HUALAPAI TRIBE
OFFICE OF THE CHAIRPERSON

June 10, 2021

Re: Comments on Sandy Valley Exploration Project (Phase 3) Environmental Assessment, NEPA Number DOI-BLM-AZ-C010-2021-0029-EA

Figure 1. Excerpt of geologic map from Davidson (1973) showing Cofer Hot Spring and associated fault (labels added).

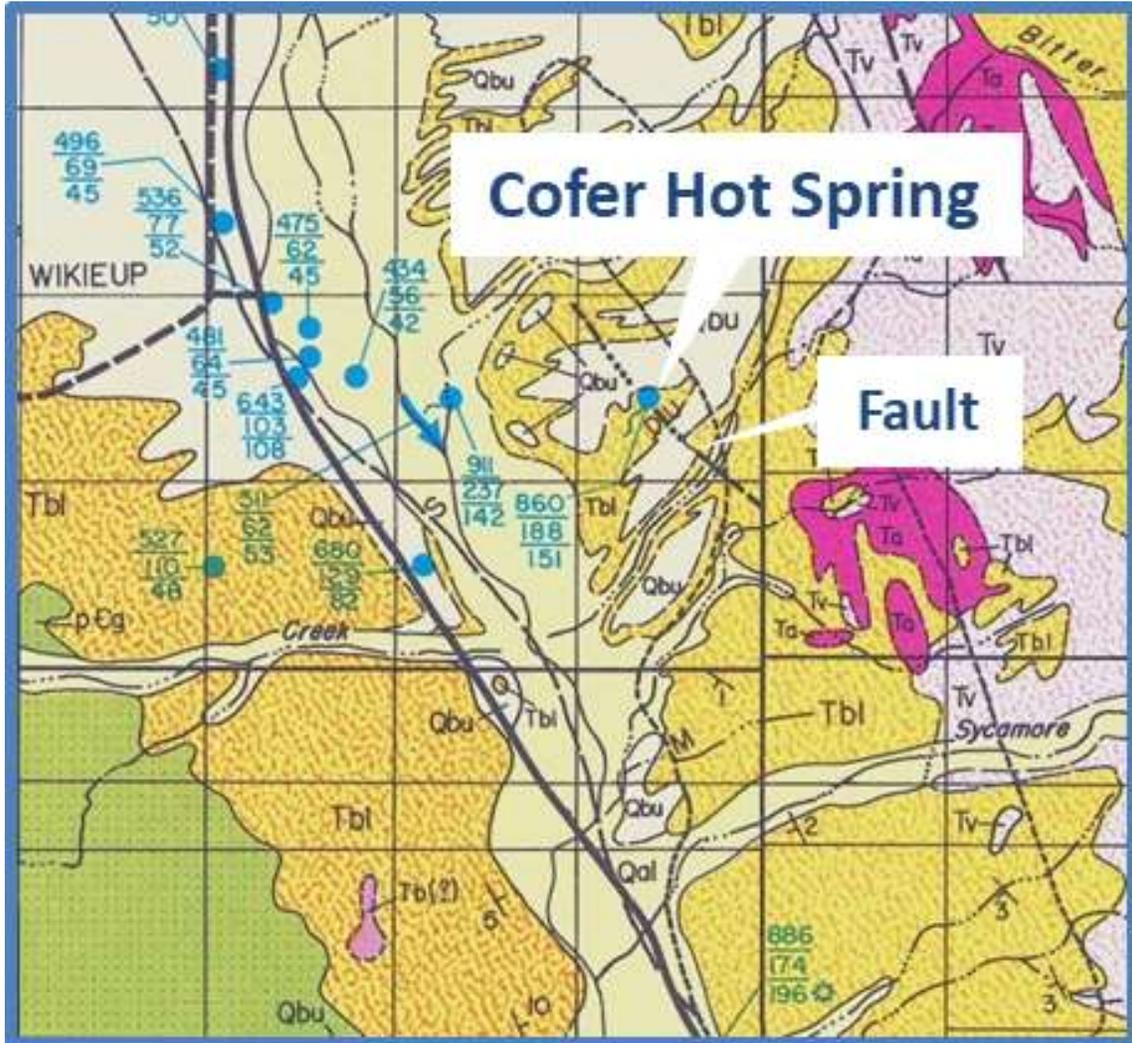
Cofer Hot Spring occurs along a geologic fault that likely serves as the conduit for thermal artesian flow from the confined volcanic aquifer to the surface. This fault was first mapped by Davidson (1973) and is shown on Figure 1. The pattern of drillholes for the proposed Phase 3 exploration program straddles the fault in the area immediately to the north and south of Cofer Hot Spring (Figure 2). Drillholes that intersect this fault, or ancillary geologic structures related to this fault, may create new conduits for artesian flow from the confined aquifer, which may result in artesian flow from drillholes. In particular, the collar elevations for proposed drillholes to the south of Cofer Hot Spring in the Bitter Creek area will be 30 to 50 feet lower than the outlet of Cofer Hot Spring. This could result in impacts to flow at Cofer Hot Spring should

uncontrolled artesian flow occur from drillholes. From review of the EA, it does not appear that the BLM/Big Sandy Inc. project team has considered these potential hydrogeologic impacts.

Figure 2. Proposed Drillhole Map – NM and NZ Areas (from BLM, 2021, Appendix D); fault and label added

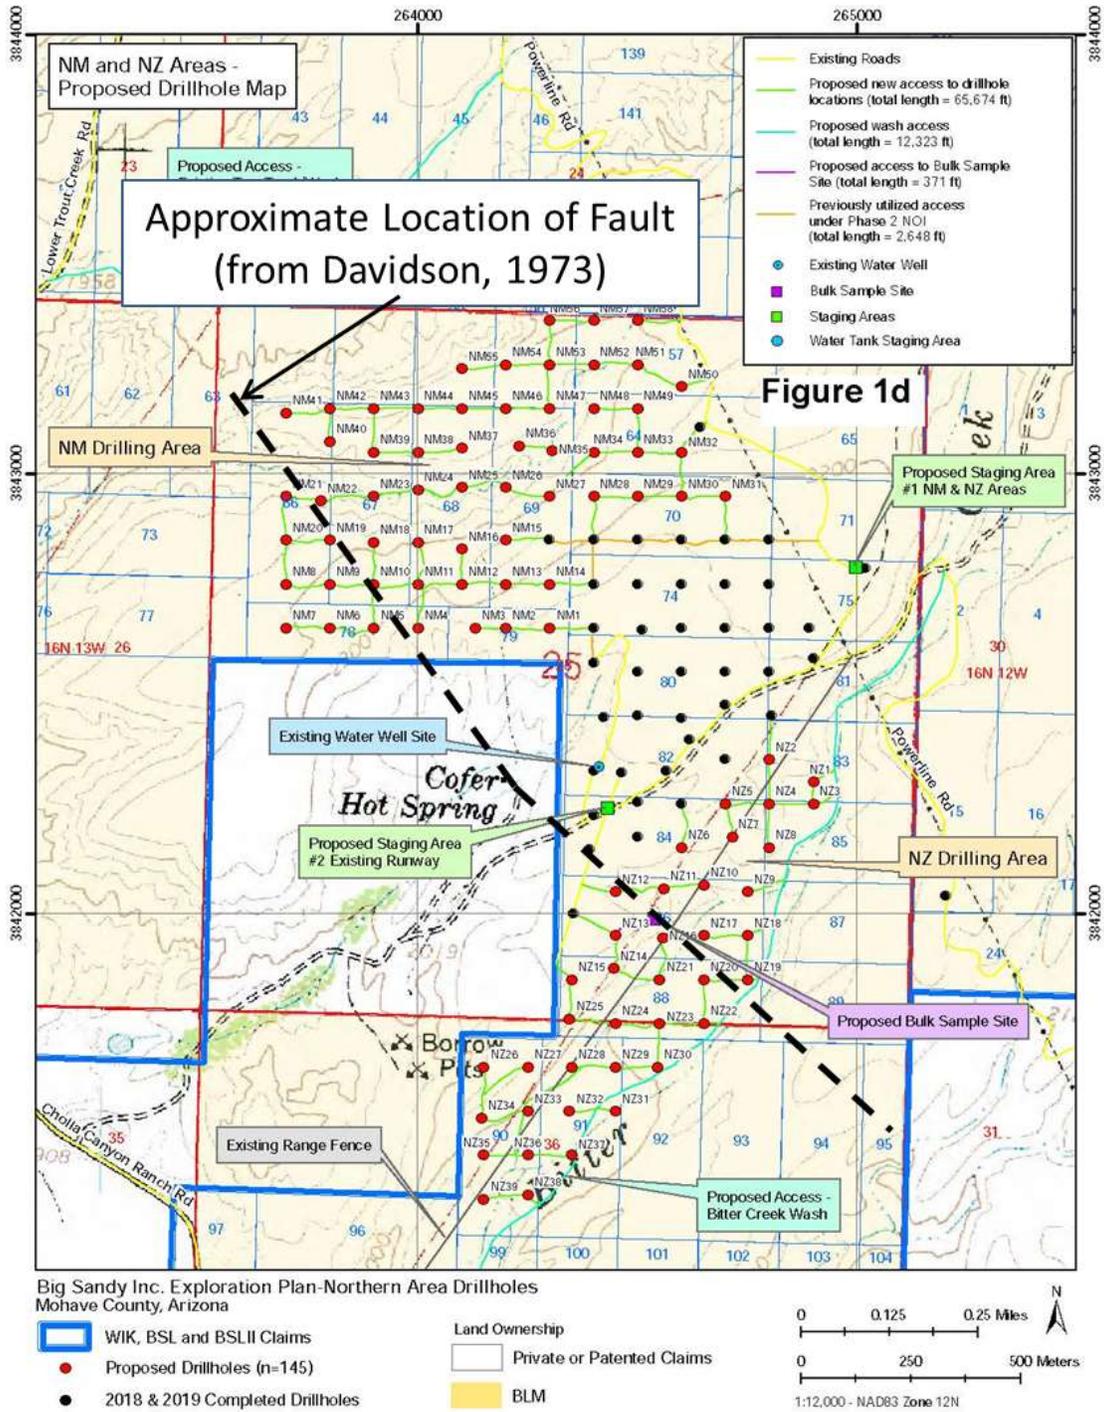
Of particular concern regarding the presently-proposed Plan is effects on the volcanic fault that supplies water to Cofer Hot Spring, which passes through the proposed drilling area in a northwest-southeast orientation. Effects on Cofer Hot Spring’s water supply inherently also raise cultural resource and traditional cultural practices concerns. We refer to the geohydrological summary by Montgomery and Associates for a more detailed discussion of potential risks (attached). The summary notes that drilling could result in impacts to thermal artesian flow to Cofer Hot Spring should uncontrolled artesian flow occur from drill holes—a possibility the summary acknowledges as real. The lack of analysis or any consideration of this risk to a National Register eligible TCP is a serious deficiency in the EA. .

The EA provides little detail and offers conflicting information regarding proposed drillhole abandonment procedures, and does not include a contingency plan for mitigating uncontrolled artesian flow should that be encountered at exploration drillholes.

Proper abandonment of exploration drillholes is an essential part of any exploration drilling plan, especially in the event groundwater is encountered. Due to the presence of geologic structures that may be intersected by planned drillholes and the potential for encountering conduits from the confined aquifer system, a more robust drillhole abandonment plan should be in place. The EA for the Phase 3 drilling program provides conflicting information on protocols to be followed for drillhole abandonment. In the Appendix D - Plan of Operations (POO), there is reference to backfilling of “coreholes” if dry conditions are encountered, but no specification of materials. The plan indicates that bentonite chips would be used if groundwater is encountered. On Figure 3 of the POO, the drillhole diagram indicates that bentonite chips would be used in dry holes and concrete grout in ‘wet’ holes. In addition to the items listed above for data collection, the following protocol is recommended for abandonment of drillholes for the Phase 3 program:

A contingency plan should be provided to describe what actions will be taken should groundwater under pressure begin to flow from drillholes. Weighted drilling muds or grouts may need to be deployed to stop uncontrolled artesian flow.
